9.2 Water Systems

The information in this section of the reference ABWR DCD, including all subsections, tables, and figures, is incorporated by reference with the following departures and supplements:

9.2.4 Potable and Sanitary Water System

9.2.5 Ultimate Heat Sink

Figure 9.2-6a Turbine Building Cooling Water System Diagram

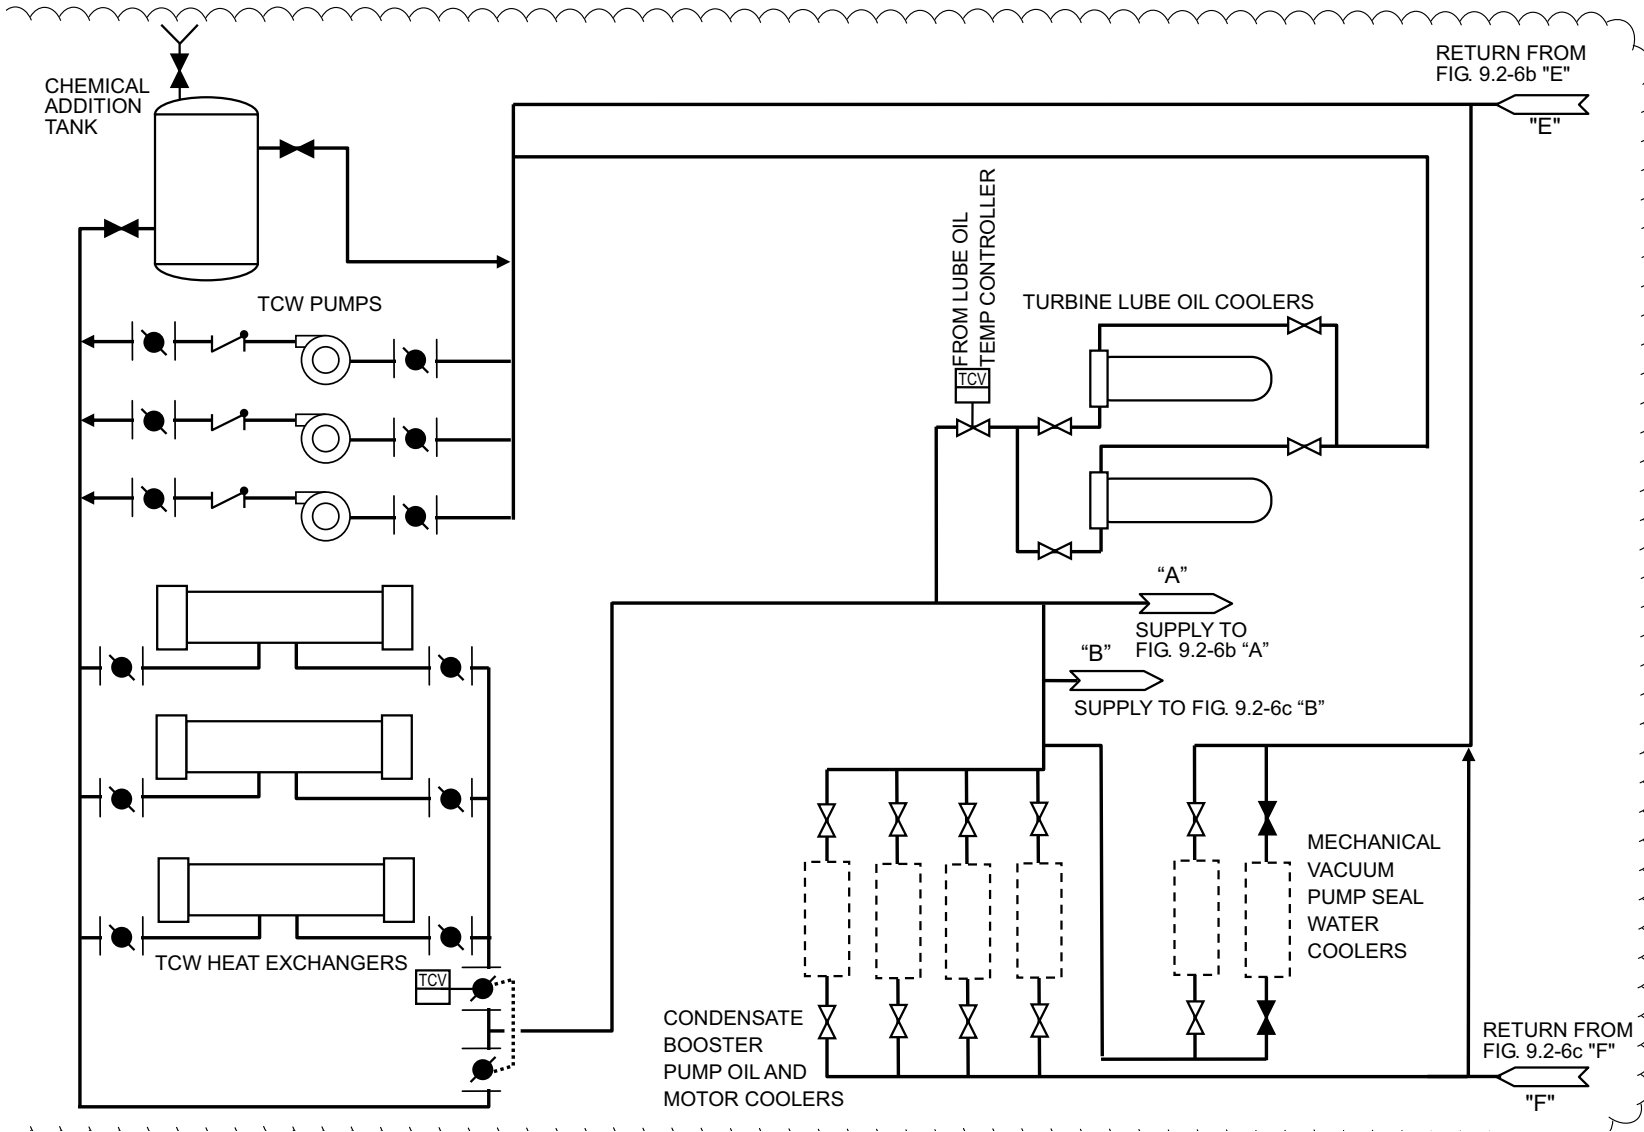
STP DEP 9.2-3 ([Table 9.2-11, Figures 9.2-6a, 9.2-6b and 9.2-6c](#))

Figure 9.2-6b Turbine Building Cooling Water System Diagram

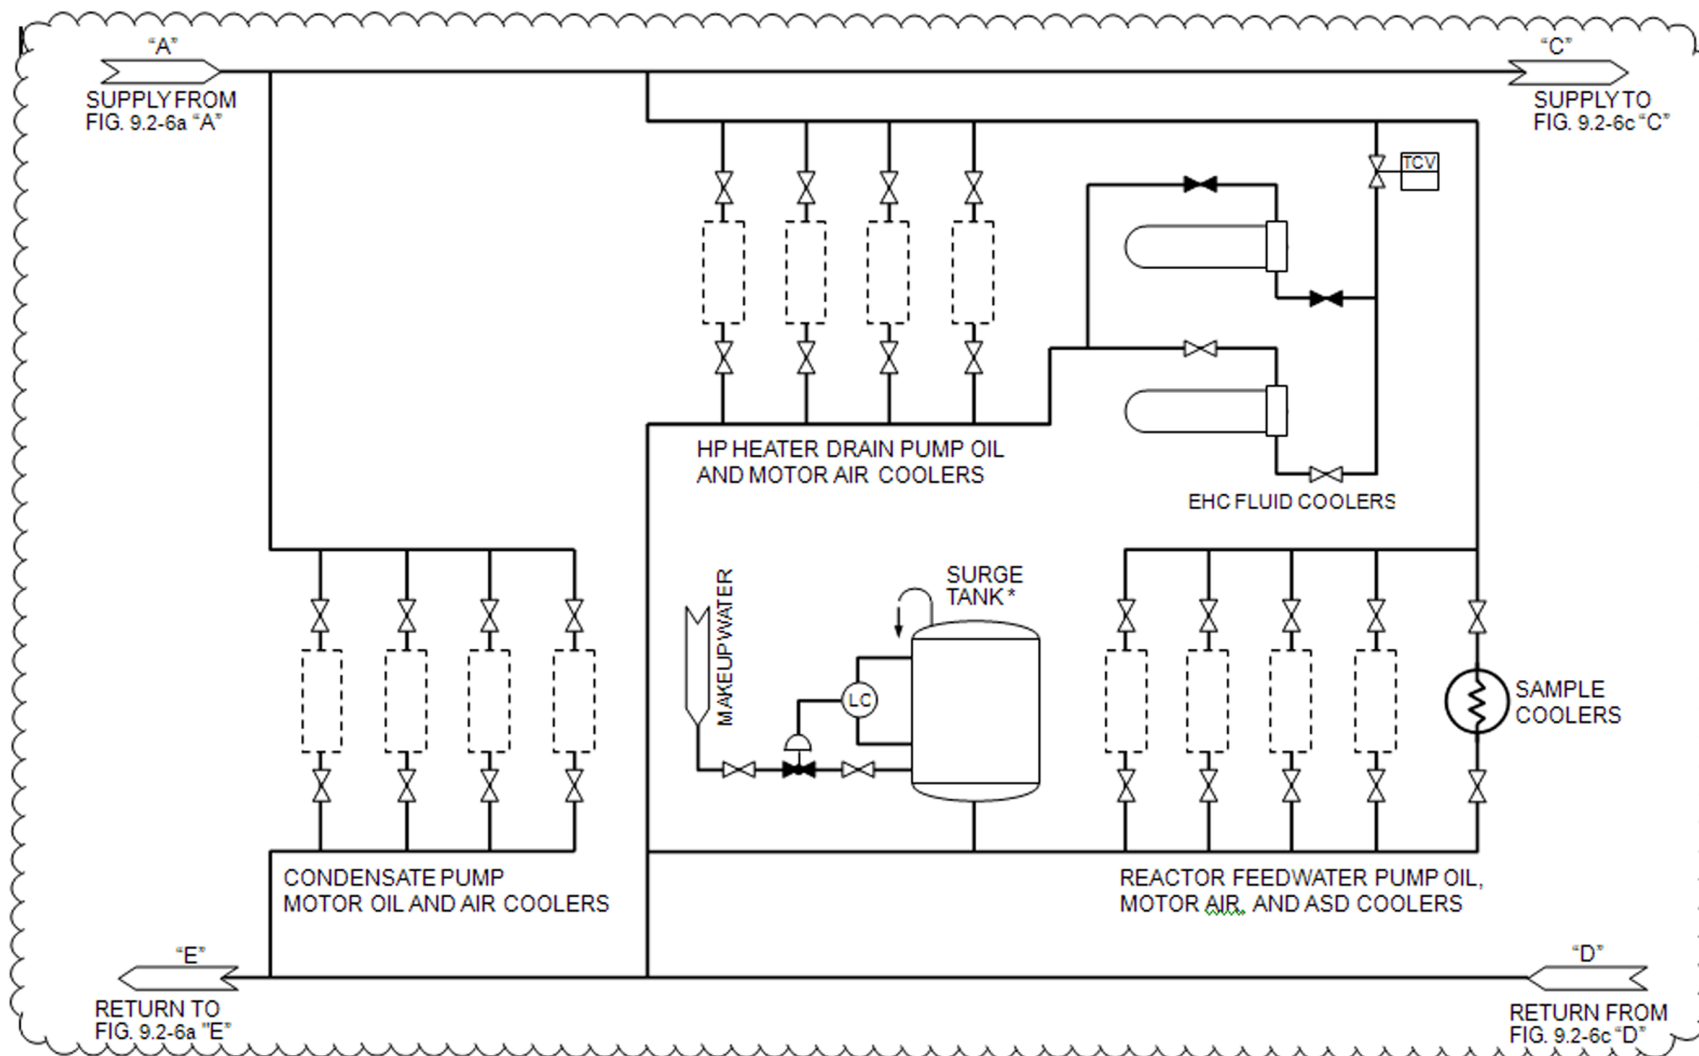
STD DEP Admin (Table 9.2-11, Figure 9.2-6b)

Figure 9.2-8 Turbine Building Service Water System

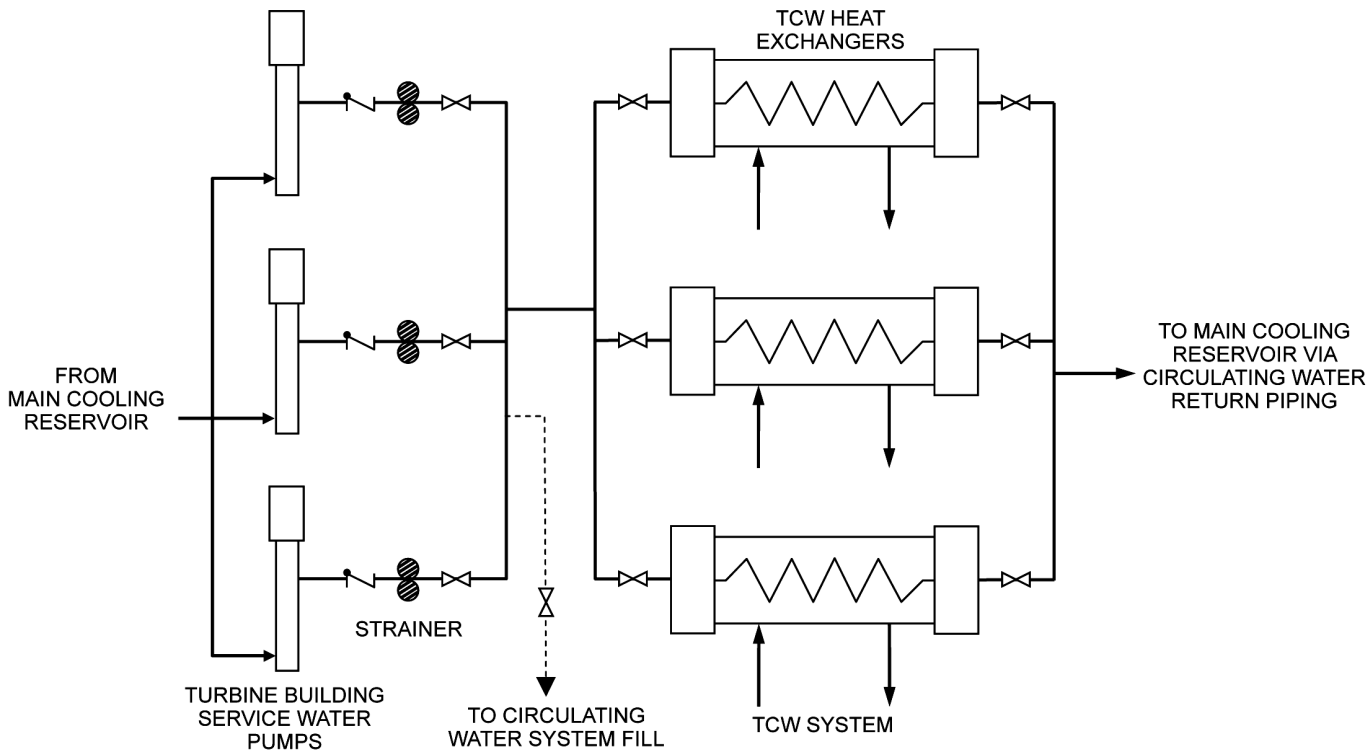
[STP DEP 9.2-10 \(Table 9.2-16, Figure 9.2-8\)](#)

The TSW system, illustrated in Figure 9.2-8 with site-specific design information, consists of three 50% capacity vertical wet pit pumps located in the circulating water intake structure. Two pumps are in operation during normal operation with one pump in standby.

Figure 9.2-9 Potable and Sanitary Water System (Sheet 1 of 2)

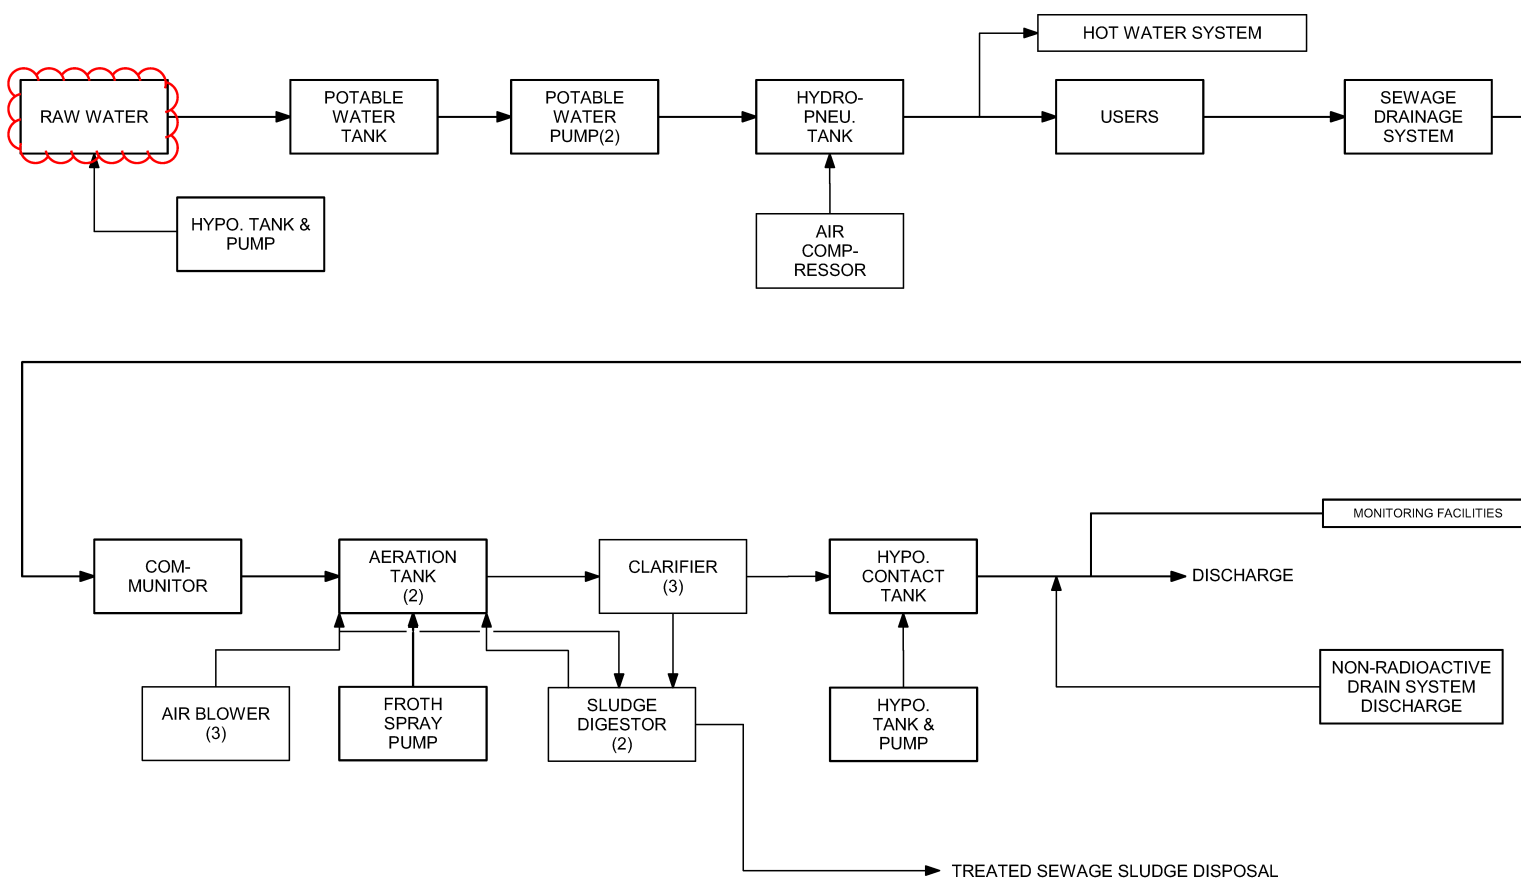
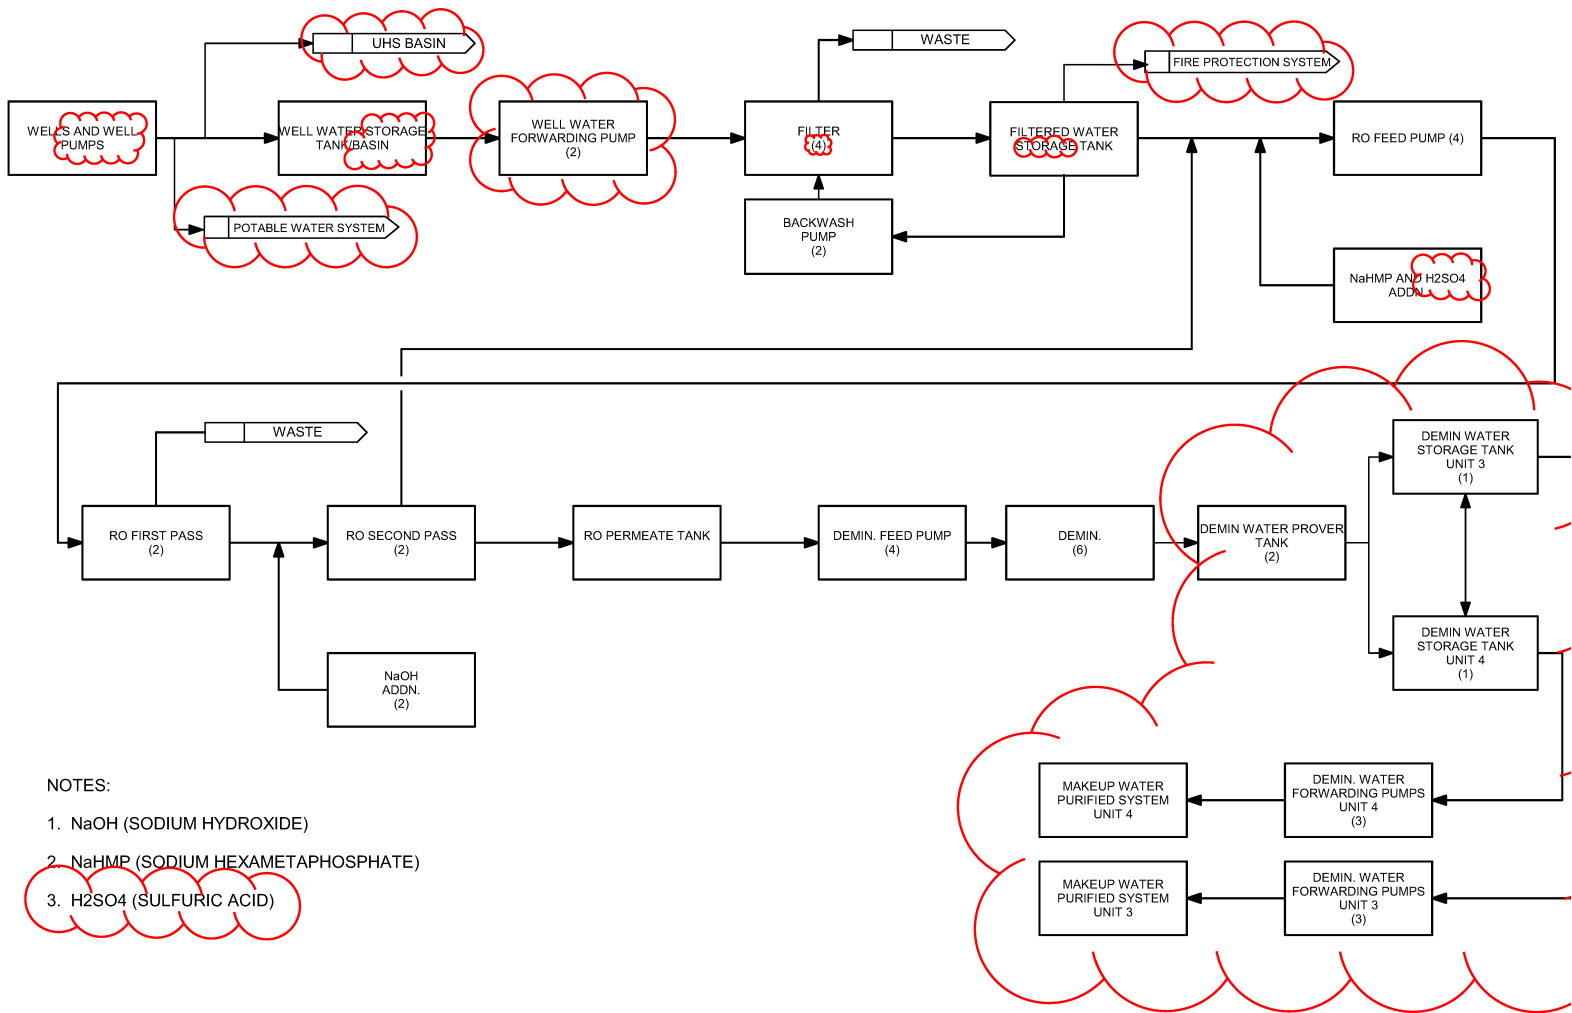
STP DEP 9.2-8 (Table 9.2-14 and Figure 9.2-9 Sheet 1 of 2)

STP DEP 9.2-8

- (1) *The PSW System is designed to provide to all buildings at STP 3 & 4 a minimum of ~~45 m³/h~~ 90 m³/h of potable water intermittently during peak demands.*

- (2) Potable water will be supplied directly off of the well water system and is ~~filtered and~~ chemically treated to prevent harmful physiological effects on plant personnel.

- (4) ~~(3)~~ The PSW System includes a sewage treatment system which treats sanitary waste for all four units at the STP site using the activated sludge biological treatment process. The aeration tanks are capable of receiving waste at a rate ~~between 45 220 m³/d and 185 480~~ of 1136 m³/d.

STP DEP 9.2-2 (Table 9.2-15, Figure 9.2-10)

The permanently installed system consists of wells, filters, RO modules, and demineralizers that prepare demineralized water from well water. The demineralized water is sent to storage tanks until it is needed. The components of the MWP system are shared components with the exception of the demineralizer water storage tanks, which are cross-connected to provide demineralized water to STP 3 & 4. The components of the MWP system are listed in Table 9.2-15 and the system block flow diagram is in Figure 9.2-10.

Two high-pressure, horizontal multistage RO feed pumps per train provide a feed pressure of approximately 3.14 MPaG. RO membranes are arranged in two parallel divisions (trains) of two passes each with the permeate of the first passes going to the inlet of the second passes. The reject or brine from the first passes is sent to the wastewater retention basin. A chemical addition tank, two pumps, and controls are provided to add sodium hydroxide to the permeate of the first pass. The reject from the second passes is recycled to the RO feed pump suction line. The permeate from the second pass is sent to a RO permeate storage tank.

In addition to the description above, each RO division can be operated in a single-pass parallel configuration to provide sufficient demineralized water during peak demands.

Figure 9.2-13 Thirty-Day Water Evaporation for Case D1

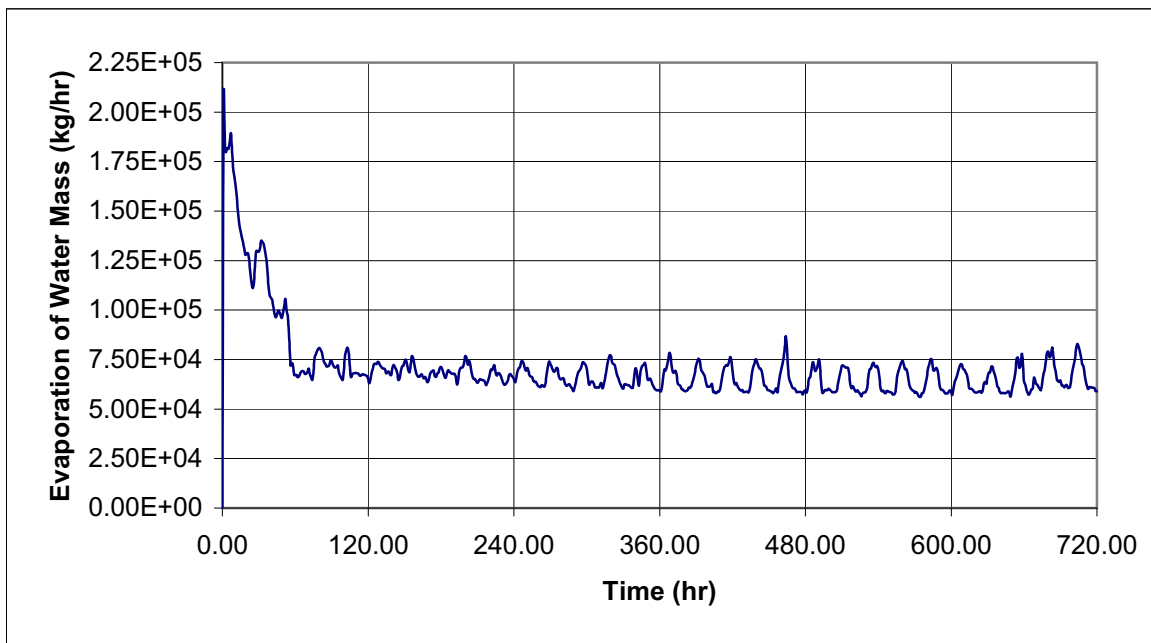
The STP 3 & 4 UHS basin water evaporations for cases D1 and D2 are plotted in Figures 9.2-13 and 9.2-14. The total amount of water evaporated over 30 days are 5.121×10^7 kilograms (Table 9.2-25) and 5.56×10^7 kilograms (Table 9.2-26), respectively.

Figure 9.2-15 UHS Basin Water Maximum Temperature (Worst 1-Day)

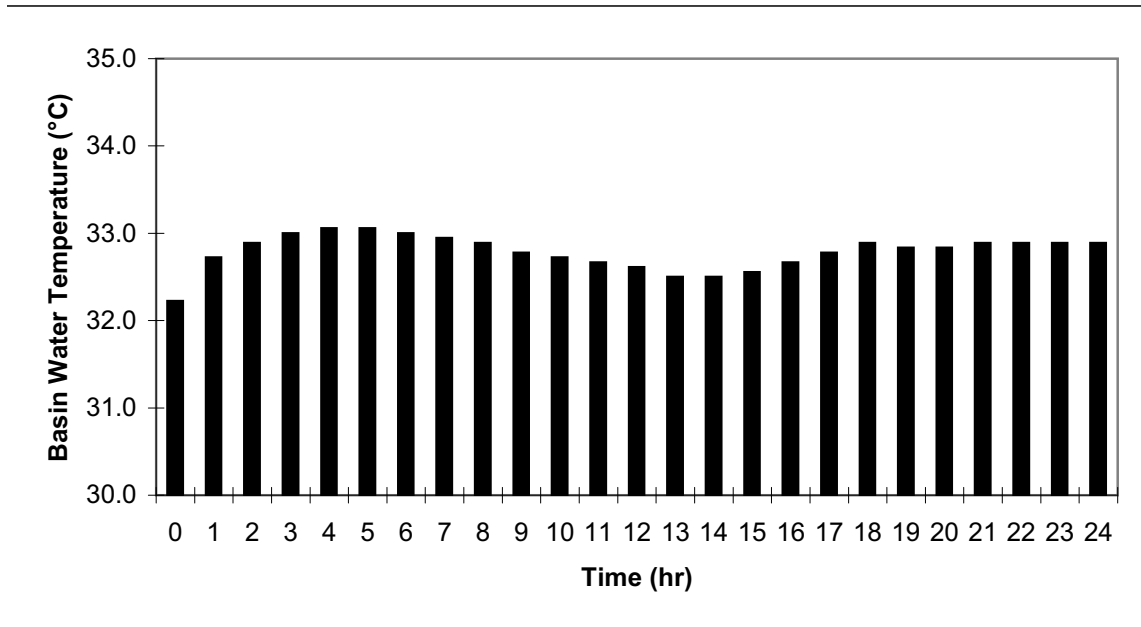
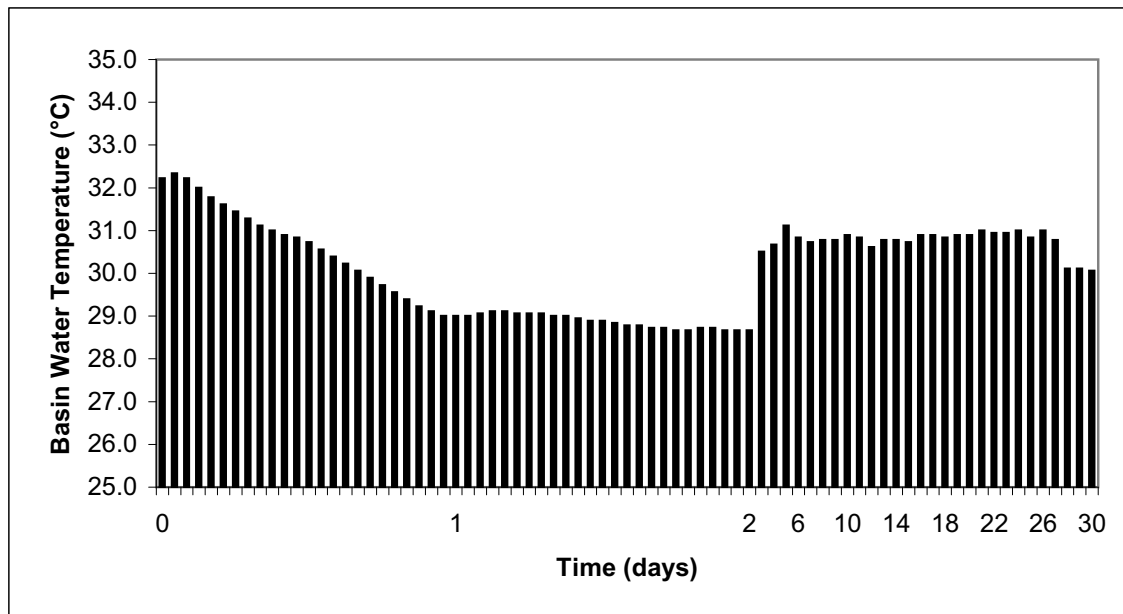
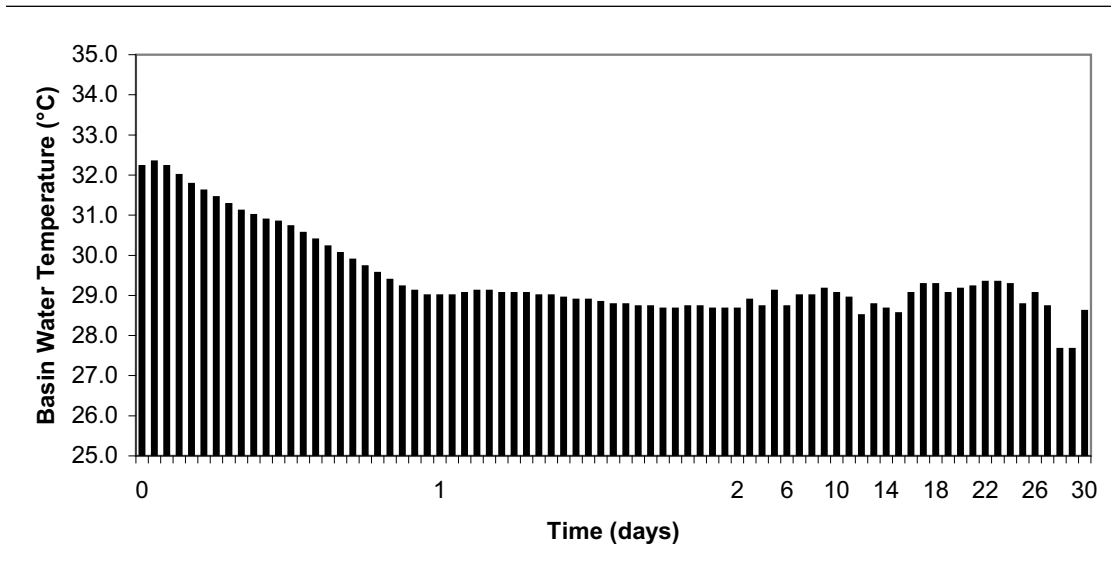
Cold water temperatures (Figure 9.2-15, 9.2-16, and 9.2-17) are determined using vendor-provided cooling tower performance curves that relate cold water temperature and wet-bulb temperature to the cooling tower range and cooling tower flow rate. The calculated cold water supply temperature after 30 days of operation following a DBA is ~~29.5~~30.1°C for Case D1 and ~~27.83~~28.6C for Case D2.
